SERVICE BULLETIN

NTB19-022

NISSAN; P0171 AND P0174 SERVICE INFORMATION

APPLIED VEHICLES:	2017-2018 Altima (L33)	2017-2019 Armada (Y62)
	2017-2019 Sentra (B17)	2017-2019 Frontier (D40)
	2017-2019 Versa Note (E12)	2017-2019 Titan/Titan XD (A61)
	2017-2019 Rogue (T32)	2017-2019 NV (F80)
	2017-2019 Murano (Z52)

FLOW CHART

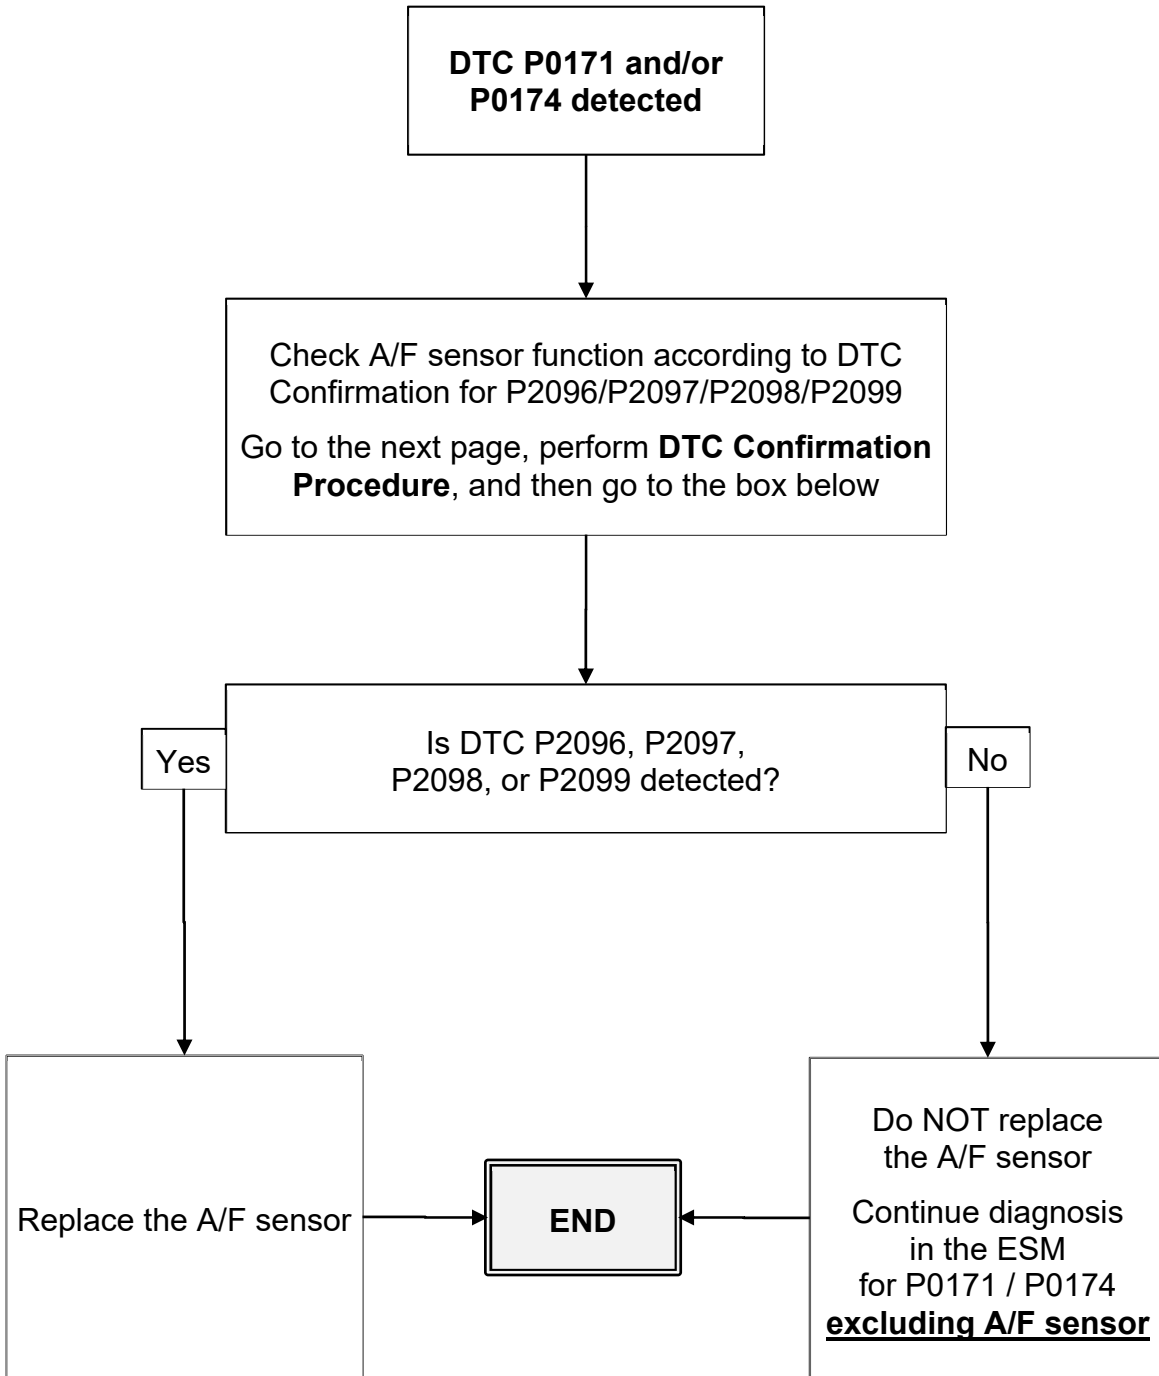
Diagnosis for DTCs P0171 (FUEL SYS LEAN B1) and P0174 (FUEL SYS LEAN B2) have been revised for the **APPLIED VEHICLES** listed above. When performing diagnosis for either of these DTCs, start by using the **SERVICE PROCEDURE** section of this bulletin.

9. Let the engine idle for 1 minute.
10. Keep the engine speed between 2,500 and 3,000 RPM for 20 minutes.
11. Check for 1st trip DTC:
 - If DTC P2096, P2097, P2098, or P2099 is stored, replace the corresponding A/F sensor.

- If no DTCs are stored, continue with the diagnosis in the ESM for P0171 / P0174 **excluding A/F sensor**.
